**MICROCHIP****PIC18F2410/2510/4410/4510****PIC18F2410/2510/4410/4510 Rev. A1 Silicon Errata**

The PIC18F2410/2510/4410/4510 Rev. A1 parts you have received conform functionally to the Device Data Sheet (DS39636C), except for the anomalies described below. Any Data Sheet Clarification issues related to the PIC18F2410/2510/4410/4510 will be reported in a separate Data Sheet errata. Please check the Microchip web site for any existing issues.

The following silicon errata apply only to PIC18F2410/2510/4410/4510 devices with these Device/Revision IDs:

FIGURE 1: SCK PULSE VARIATION USING TIMER2/2

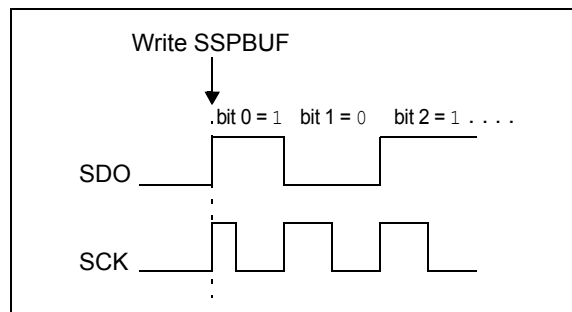
When the SPI is using Timer2/2 as the clock source, a shorter than expected SCK pulse may occur on the first bit of the transmitted/received data (Figure 1).

To avoid producing the short pulse, turn off Timer2 and clear the TMR2 register, load the SSPBUF with the data to transmit and then turn Timer2 back on. Refer to Example 5 for sample code.
